SURFACEWATER IMPROVEMENT PROJECT

Bend, OR

FINAL VALUE ENGINEERING STUDY REPORT

Prepared for:

1E-02: PLC System Overview

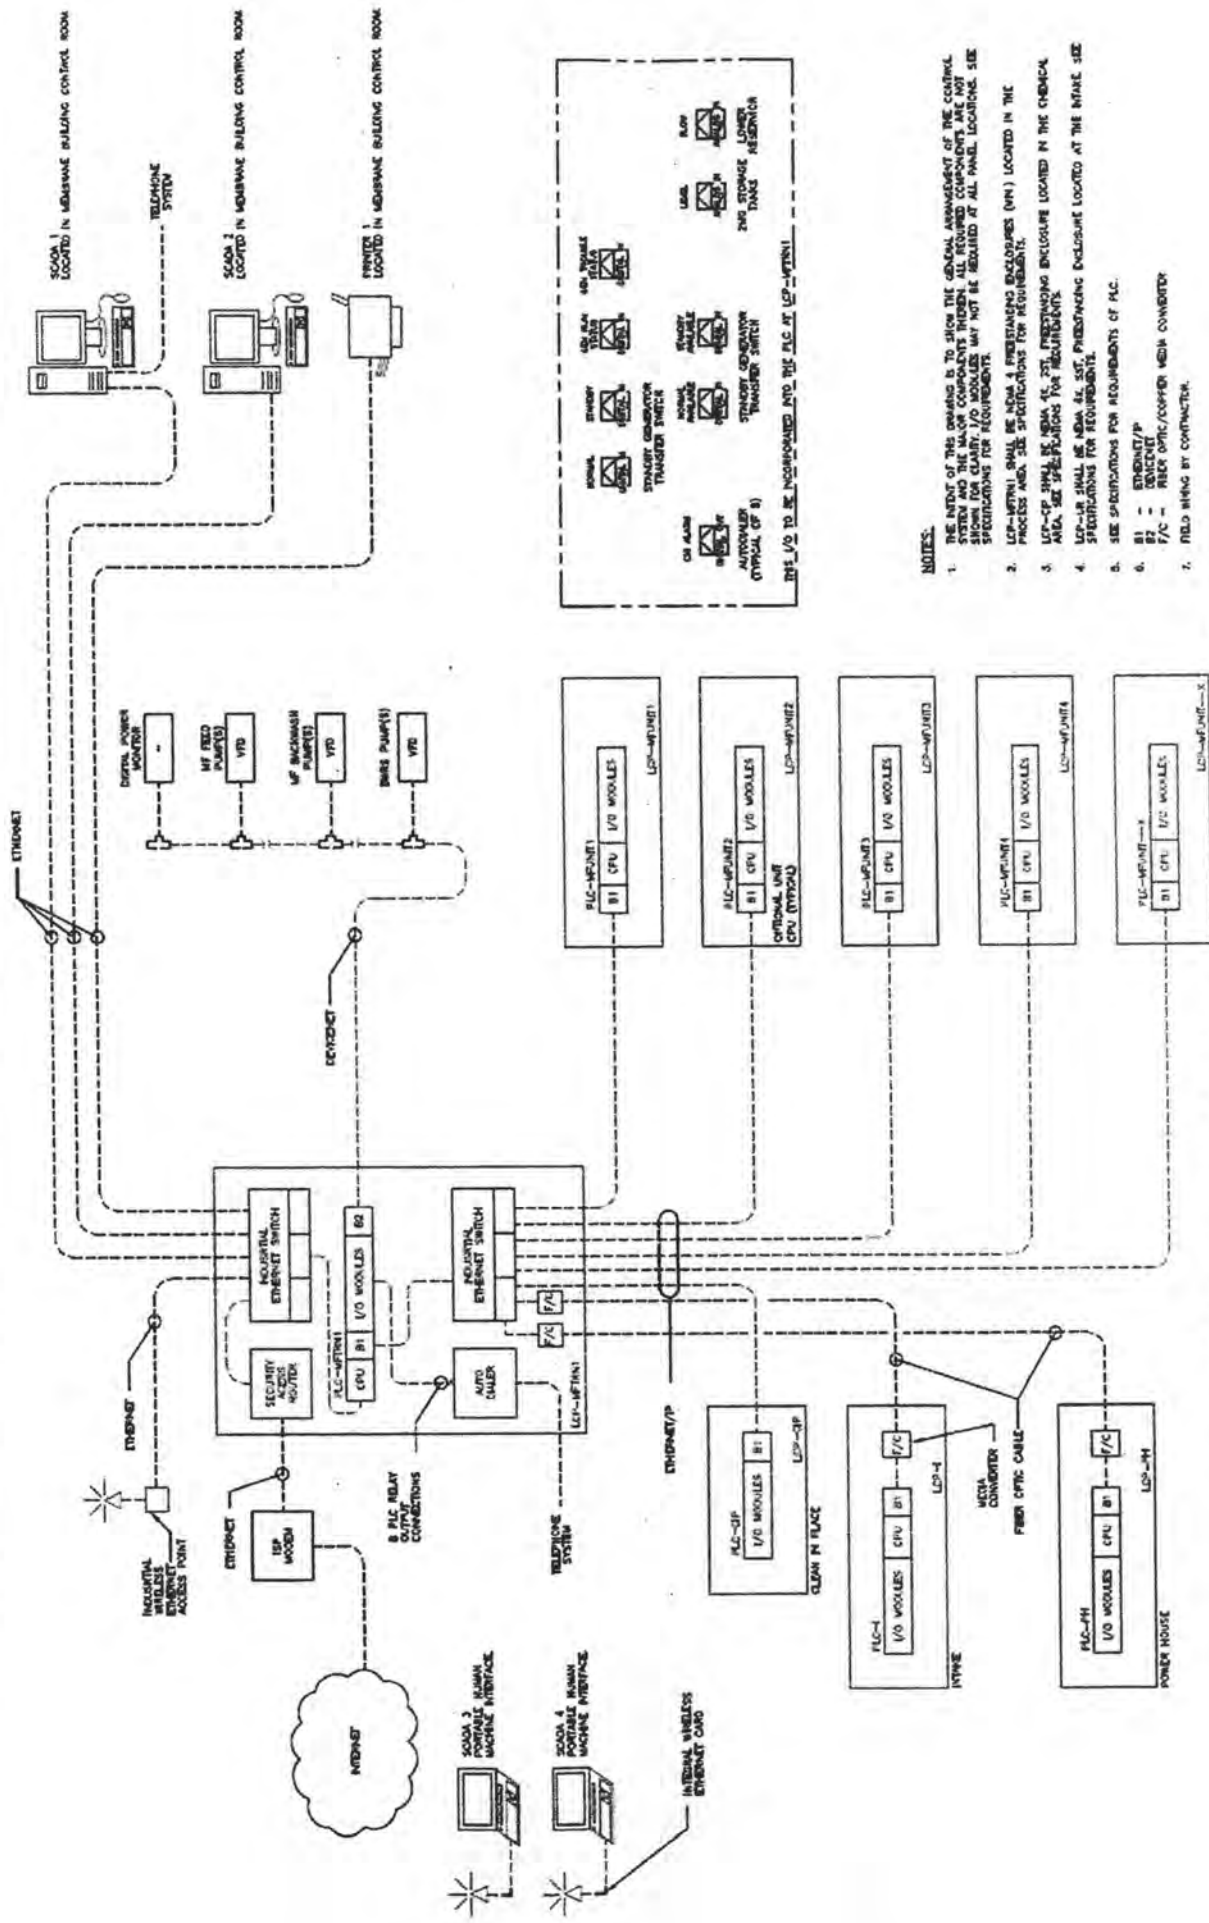
This eliminates the 10 to 15 local process based PLC's. A single redundant PLC will be simpler to program and coordinate and is more typical of system design.

~~USE REDUNDANT PLC WITH FIELD RIO~~

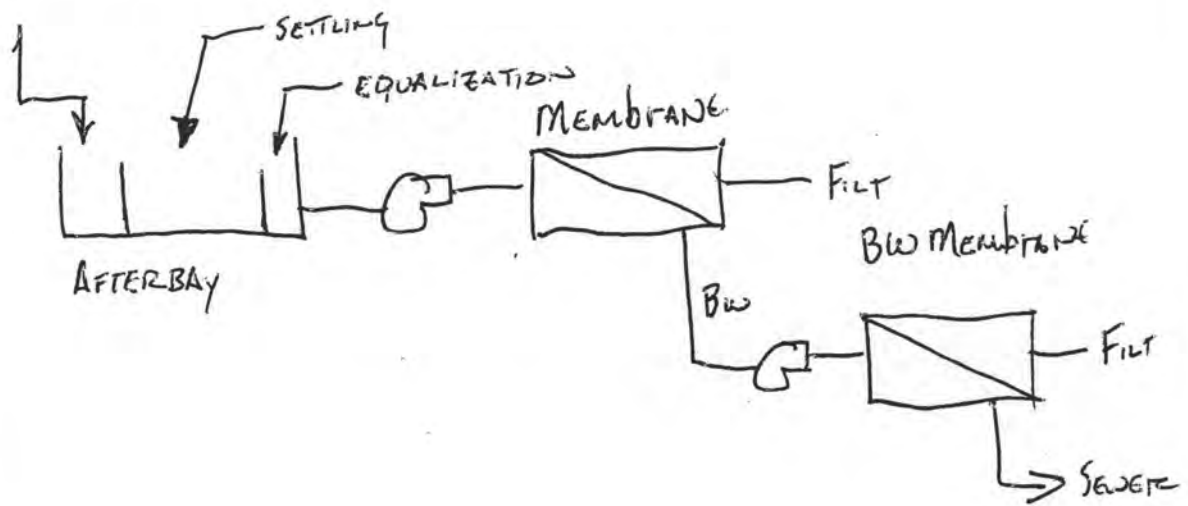
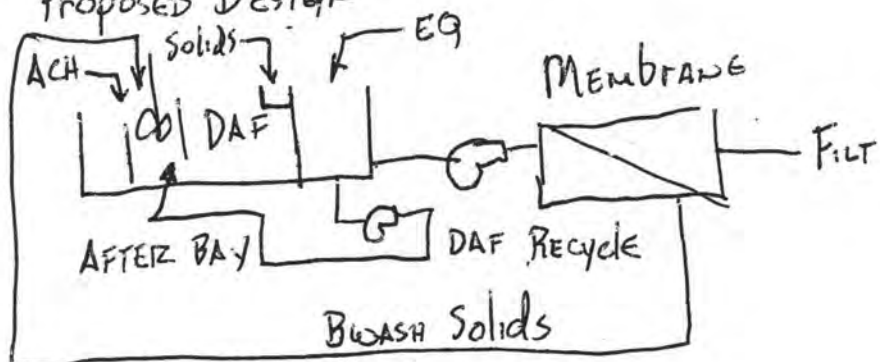
Total amount of solids that can be delivered to the facility is estimated at approximately 47 lbs/day based on a TSS of 0.5 mg/L at 11.25 mgd average flow, typical for the turbidity levels offered in the basis of design report. These solids are discharged to the sewer in a volume of 108,000 gallons per day.

Coagulant (ACH or PaCL) will be added to the feedwater to enhance settling. It can be assumed that the amount of coagulant will be equal to the amount of solids, resulting in a solids load of 94 lbs/day. Although DAF can produce up to 2 or 3 percent solids, a more liquefied stream of 0.5 percent solids can be assumed to maintain liquefied form of the waste suitable for disposal in a sanitary sewer. Using these assumptions, the amount of liquid backwash discharged to the sewer would be approximately 2,500 gallons per day.

This approach would eliminate the need for a backwash treatment membrane system, and interconnected unit. Since exact membrane system pricing has not been established a reduction of 10 percent of the system cost has been used for a basis of design. This value accounts for the fact that the backwash membrane system would be operated at a lower membrane flux than the primary membrane system.

SCHEMATIC PLAN - BACKWASH
SETTLING POND

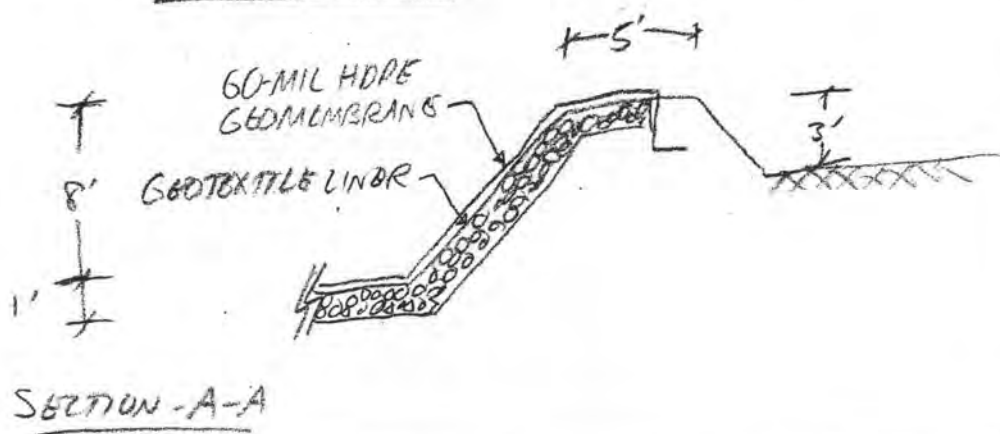
The proposed concept would construct two earthen ponds on the Outback site to receive the filter backwash flow from the membrane treatment plant. The ponds will be sized to each handle the plants full design capacity of filter backwash so that one can be taken off-line, drained, and the solids removed on an annual basis. Pond detention time would be 24 hours. The settling ponds will be 35' x 70' and 5 feet deep excavation with a 3-foot tall berm above finished grade, lined with a 60-mil HDPE geomembrane liner. Backwash decant would be conveyed to the ponds with a buried 3-inch main. Each pond will have a single access ramp, 8-inch distribution header and a 2-foot wide by 7-foot tall overflow weir gate outlet box. A pump would be used to return the settled backwash water to the afterbay at the head of the treatment plant with a 3-inch buried pipeline.

Remaining flow in the waste forcemain would be due to periodic membrane cleaning operations with a peak of 30,000 gpd.
